**Site Specific Environmental
Authority Application for
Petroleum Lease (PL) 1059 –
Towrie development**

**Response to Notice of
Information Request –
Application Reference No:
APP0072009/PL1059**

Figure 1 Produced water process flow diagram

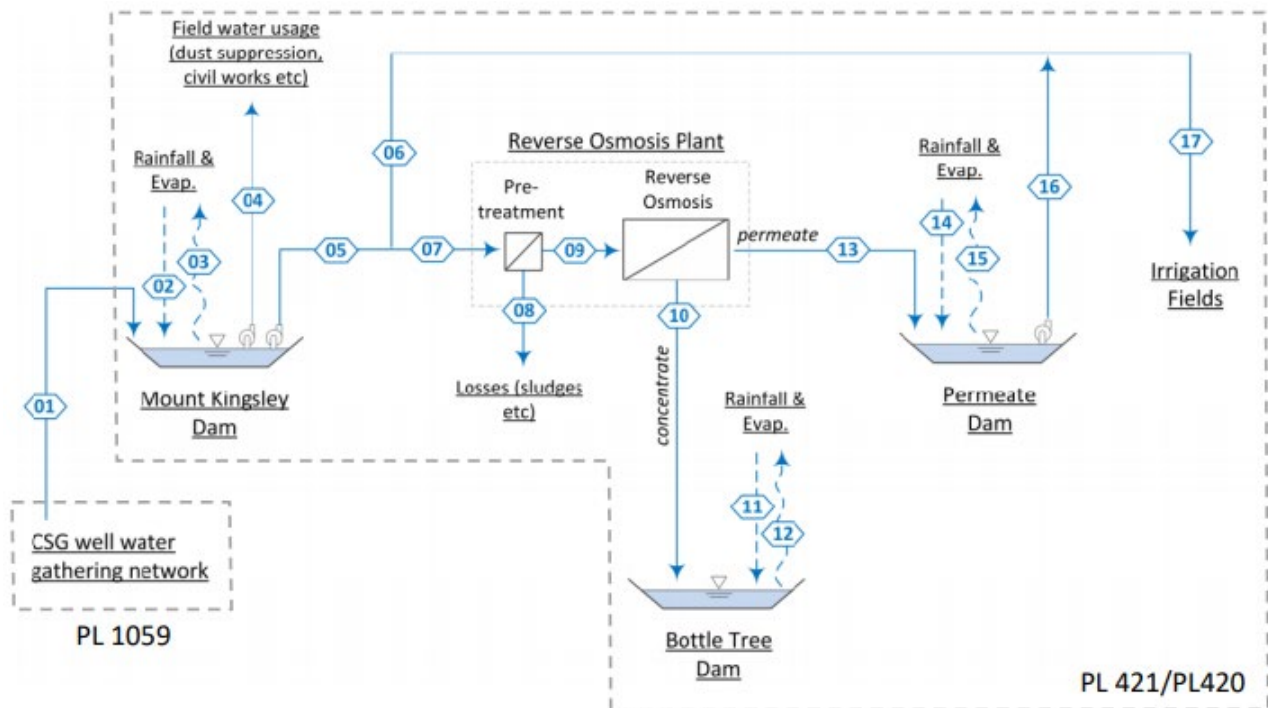
1. *The application states that produced water will be sent to PL421 for storage and management as authorised under EPPG00928713 however there does not appear to be a water treatment facility authorised within PL421 under this EA. Please confirm whether produced water will be transported and managed under the water treatment facilities authorised under EPPG00928713 which are located in PL100 and PL232 or at a separate water treatment facility.*

2. *Provide additional information on the proposed management of produced water including:*
 - a. *Expected volume to be transferred to adjacent water facilities*

Figure 1 presents the indicative water management process for the proposed activities. It includes well water gathering and onsite use within PL1059, with treatment and beneficial reuse off PL1059.

- The majority of produced water from PL1059 will be transferred to existing water management facilities on PL421. The peak water production for the project is predicted to occur in Year 7 of the project with a peak rate of 2.2 ML/day.

All water transferred to PL421 would be managed in accordance with the conditions of EA EPPG00928713. Water from PL1059 will be mixed with produced water generated under the FAPA EA and managed in accordance with existing practices. As previously mentioned this includes beneficial reuse for irrigation and other onsite activities.
